## DRAINAGE AND TRANSPORTATION INFORMATION SHEET (REV 01/06 - KDM)

Re: The Jones's Home

9000 Alameda Ave NE Grading and Drainage

**Engineers Stamp Date 8/20/2015 (C20D073)**

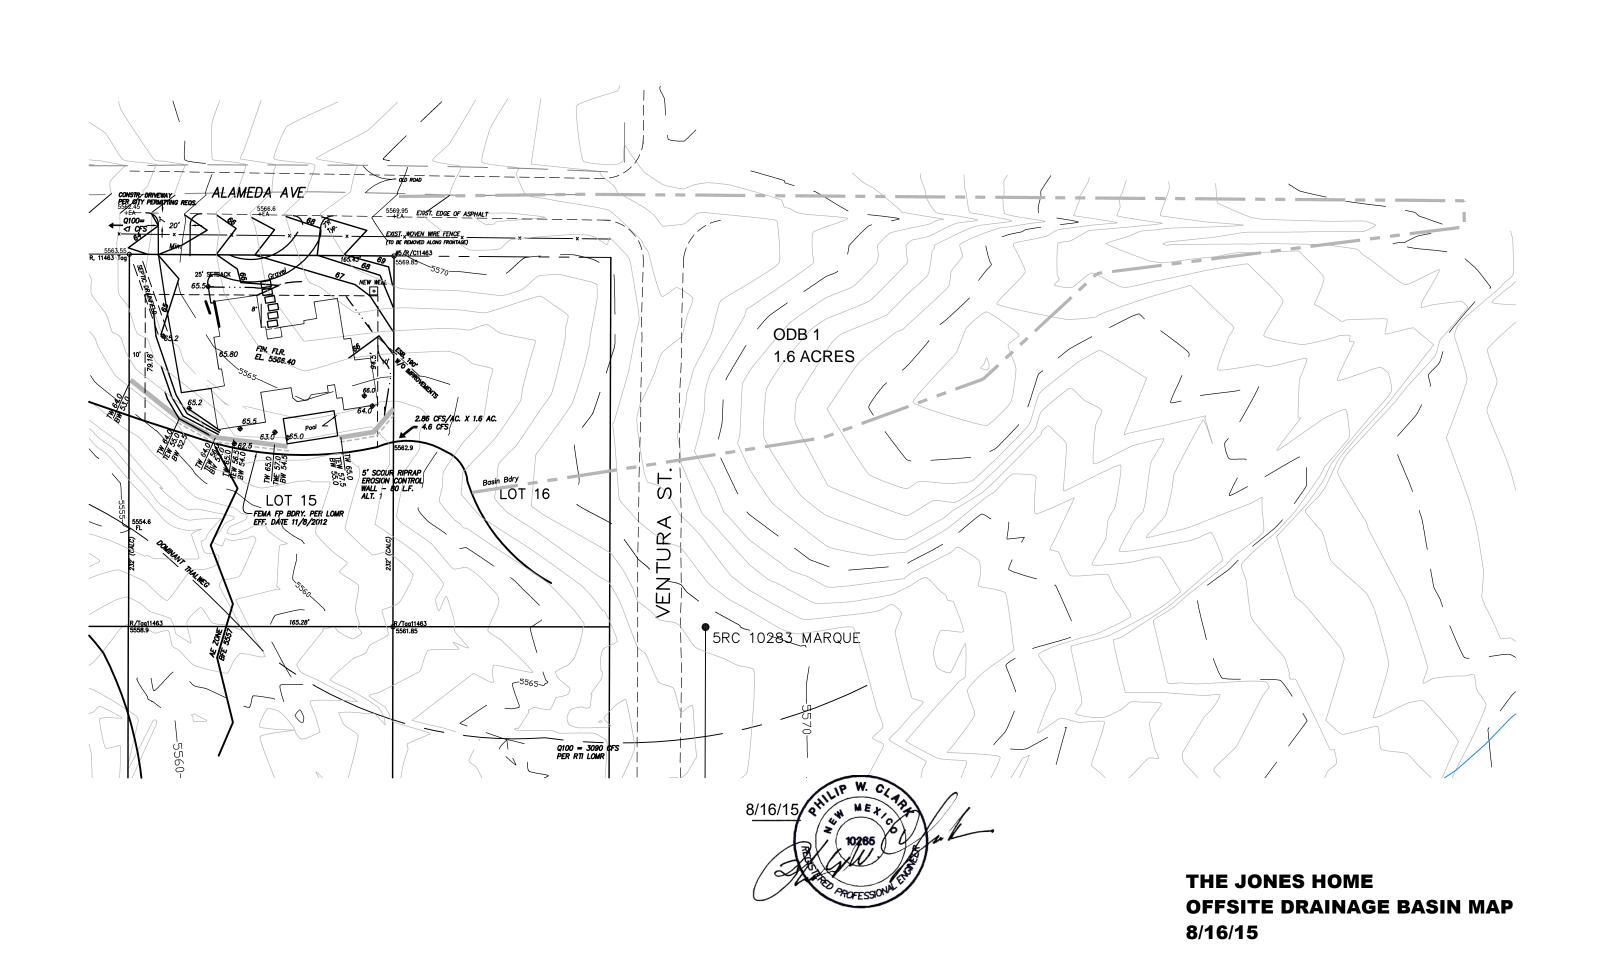
- Provide the location of the septic tank.
- Provide the specifications for the interlock retaining wall and scour wall system showing the tension fabric and other specifications.
- I calculated a Center Line Setback of 210', compared to your 190', please verify.
- Provide a concrete driveway up to the property line. Only one driveway is allowed off of Alameda.

• Provide reason for no scour wall to the south of the pool.
